Access Compliance Report

Public Rights-of-Way

(Curb Ramps)

Intersection ID: 52340	Main Street: FRED_D_ALEXANDER_BV	Cross Street: BROOKSHIRE_BV	Location: NW
ADA ID: 401022BBC66D	Ramp Type: Perp	Initial Pass/Fail: Fail	Overall Compliance: No
Severity Score: 13.75			
Codes/Mitigation Info/Possible Solution		Field Measurements/Component Compliance

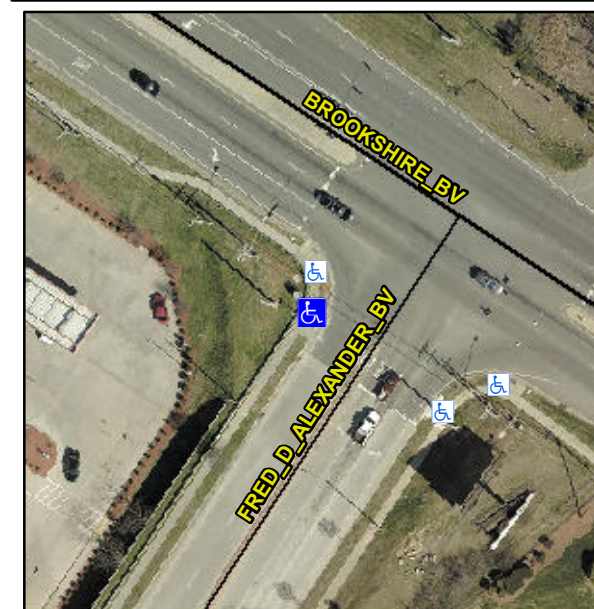
Not Found, R304.2.2, R304.5.3

Compliance	Description	Data	Compliance	Description	Data
N/A	Ramp Length (in)	41.0	No	Ramp Slope (%)	8.4
Yes	Ramp Width (in)	48.0	No	Ramp XSlope (%)	4.0
N/A	Flare Type LT	N/A	N/A	Flare Type RT	N/A
N/A	Flare Slope LT (%)	N/A	N/A	Flare Slope RT (%)	N/A
N/A	Flare Traversable LT?	N/A	N/A	Flare Traversable RT?	N/A
N/A	Landing Length (in)	N/A	N/A	DWS Provided?	N/A
N/A	Landing Width (in)	N/A	N/A	DWS Contrast?	N/A
N/A	Landing Slope (%)	N/A	N/A	DWS Length (in)	N/A
N/A	Landing X Slope (%)	N/A	N/A	DWS Full Width?	N/A
N/A	Landing Curb? (Y/N)	N/A	N/A	DWS Offset (in)	N/A
N/A	Shared Landing?	N/A			
N/A	Gutter Ponding?	N/A	N/A	Gutter Slope (%)	N/A
N/A	Gutter Lip Ht (in)	N/A	N/A	Gutter X Slope (%)	N/A
N/A	Painted X Walk1?	Yes	N/A	Painted X Walk2?	N/A
	X Walk 1 Direction	To SE		X Walk 2 Direction	N/A
N/A	X Walk 1 Width (in)	90.0	N/A	X Walk 2 Width (in)	N/A
	X Walk 1 Slope (%)	2.5		X Walk 2 Slope (%)	N/A
	X Walk 1 X Slope (%)	2.8		X Walk 2 X Slope (%)	N/A

Remove & Replace Entire Ramp.
